April 29, 2009
NND-09-0064

Subject: Virgil C. Summer Nuclear Station (VCSNS) Units 2 and 3 Combined License Application (COLA) - Docket Numbers 52-027 and 52-028 Supplement 1 to the Response to NRC Request for Additional Information (RAI) Letter No. 031

NRC RAI Letter No. 031 Dated February 19, 2009

SRP Section: 2.5.4 – Stability of Subsurface Materials and Foundations

FIG. 2. SPT Clean-Sand Base Curve for Magnitude 7.5 Earthquakes with Data from Liquefaction Case Histories (Modified from Seed et al. 1985)

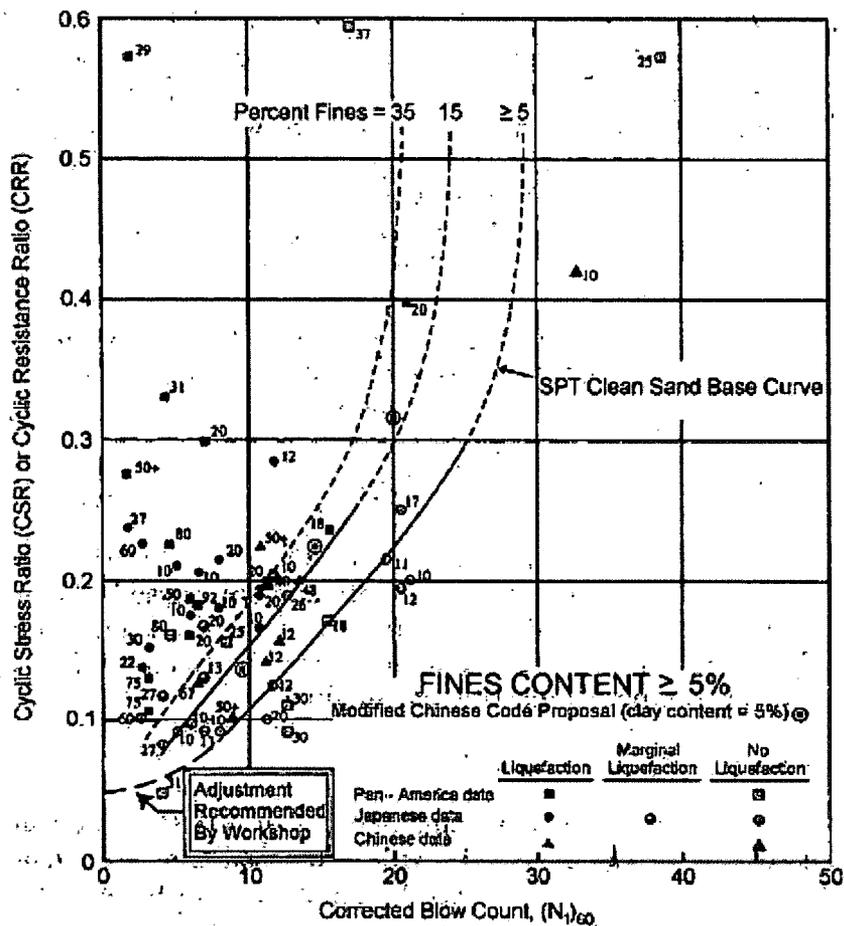
FSAR Section 2.5.4.8 (pg 2.5.4-30) states that a liquefaction analysis for the structural backfill adjacent to the nuclear island was not performed, citing that the backfill was dense and well compacted and would not liquefy. Regulatory Guide 1.206 states that "[i]f the foundation materials at the site adjacent to and under safety-related structures are soils or soils that have a potential to become saturated and the water table is above bedrock, the applicant should provide an appropriate state-of-the-art analysis of the potential for liquefaction at the site." The nuclear island depends on the stability of the backfill for resistance to sliding and rocking. FSAR Figure 2.5.4-242 presents values of the predicted peak ground accelerations, and those for saprolite are relatively high.

In order for the staff to adequately evaluate liquefaction potential at the site, please perform a liquefaction analysis to confirm stability of the structural fill.

The attached Figure 2 of Youd et al (2001) shows the Cyclic Stress Ratio (CSR) plotted against the corrected SPT blow count. The 3 curved lines represent the cut-off for liquefiable and non-liquefiable soils – each line represents a different fines content. Points on the plot that fall to the left of the line are potentially liquefiable and a calculation must be made to compute the factor of safety against liquefaction based on several factors such as peak ground acceleration and earthquake magnitude.

Points that fall to the right of the line represent soils that are too dense to liquefy. For the selected structural fill, fines contents of 5 and 10 percent were measured, and thus it is reasonable and slightly conservative to use the furthest right of the 3 lines. Now the corrected blow count in Figure 2 is $(N_1)_{60}$ which is N_{60} corrected for overburden pressure. This correction is made to standardize the blow count because measured N-values increase with overburden stress. In the case of the $N_{60} = 40$ bpf, the depth at which the $N_{60} = 40$ bpf occurs is not defined. For the compacted fill, the $N_{60} = 40$ bpf can be considered to be the same as $(N_1)_{60} = 40$ bpf, since, in reality, the measured N-value in the 40 ft of fill would increase with depth, and the N-value then corrected for overburden stress is 40 bpf.

$(N_1)_{60} = 40$ bpf is to the right of the selected line in Figure 2 and thus the compacted fill is considered non liquefiable. Note that $(N_1)_{60} = 30$ bpf also falls to the right of the selected line.

Measured Unit 2 shear wave velocity in 4 borings (2 beneath nuclear island, 2 outside nuclear island (FSAR Figure 2.5.4-224)

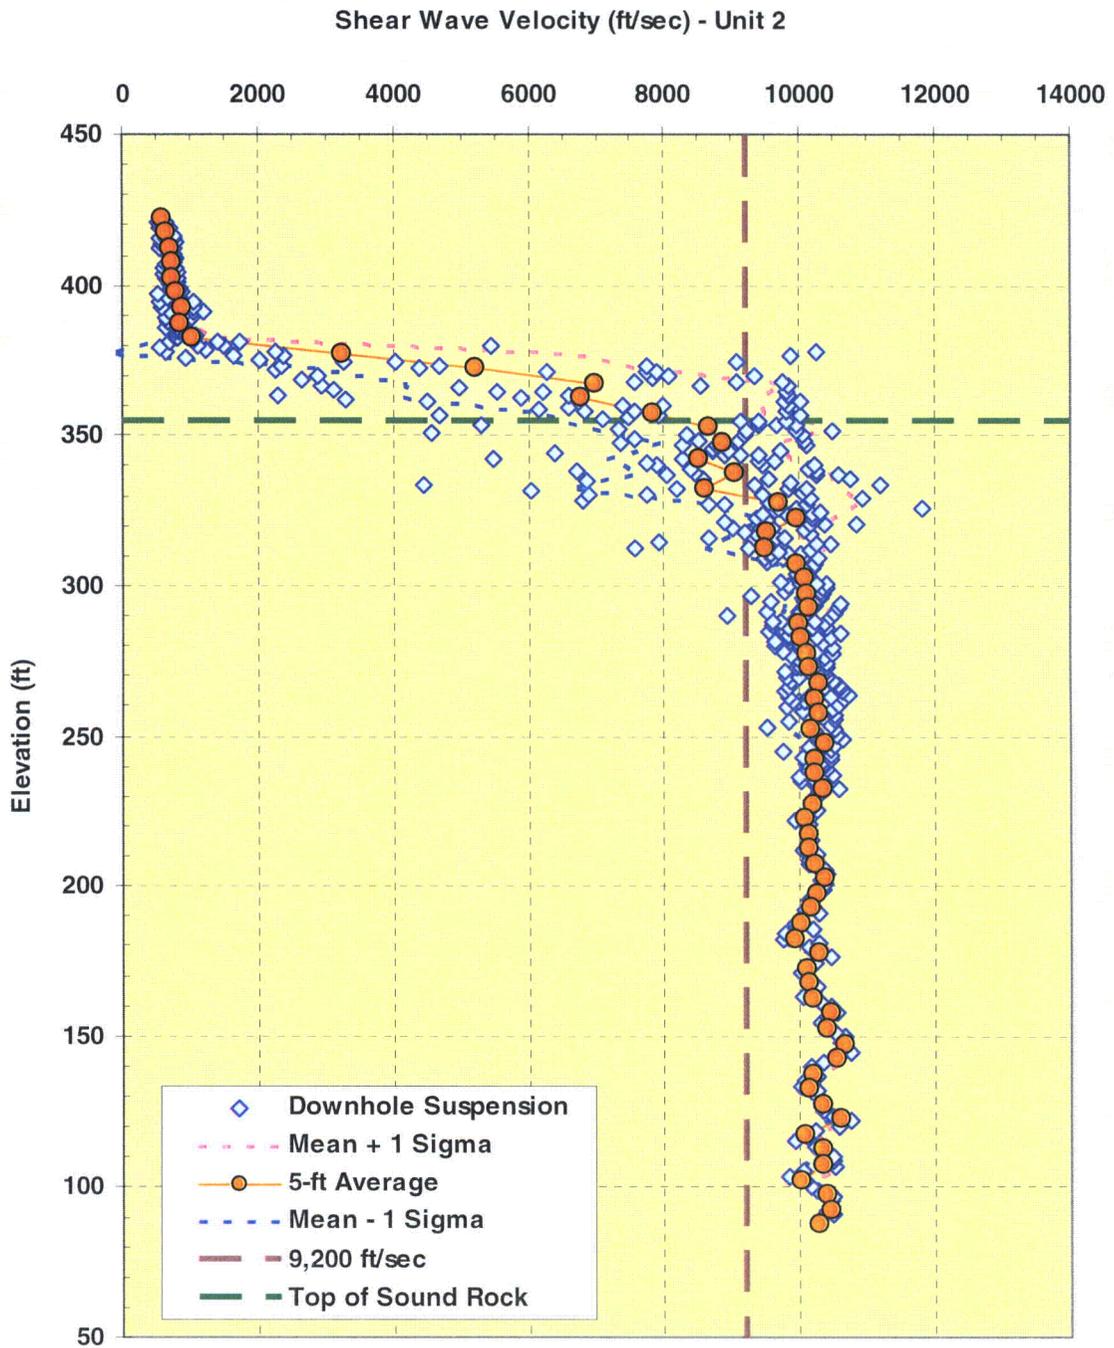
FSAR Figure 2.5.4-226 shows the mean plus and minus 1 standard deviation shear wave velocity profiles for Units 2 and 3 below basemat elevation 355. It is assumed that the data shown in Figure 2.5.4-224 was used to develop Figure 2.5.4-226. It is observed from Figure 2.5.4-224 that two borings, B-201 and B-206, exhibit the lowest shear wave velocities recorded between El. 315 and 355 of the four shear wave velocity profiles shown. A review of the locations of these borings shows that Borings B-201 and B-206 are within the footprint of the nuclear island, but B-207 and B-211 are considerably outside of the NI footprint. Averaging the four shear wave velocity profiles (borings B-201, B206, B207 and B-211) yields a higher mean shear wave velocity profile than if only B-201 and B-206 were used.

In order for the staff to assess shear wave velocity data, please provide additional information to address the effects on the site response if only B-201 and B-206 were used to define the shear wave velocity profile.

The RAI correctly assumes that the data shown in FSAR Figure 2.5.4-224 were used to develop Figure 2.5.4-226. In these figures, the shear wave velocity (V_s) data are from the four Unit 2 boreholes in which V_s was measured, i.e., B-201 and B-206 within the nuclear island, and B-207 and B-211 outside the nuclear island. These figures are included at the end of this response. In addition, the figures have been redrawn using the V_s data from only the two nuclear island borings, and are included at the end of this response (referred to here as Figures 2.5.4-224RAI and 2.5.4-226RAI).

As noted in the RAI, the average values of V_s between about El. 315 ft and El. 355 ft are less for the two nuclear island profiles than for all four profiles. The questions to be answered when considering these differences are (a) are the differences significant from a site response standpoint, and (b) from geology considerations, should only the V_s values measured beneath the nuclear island be used?
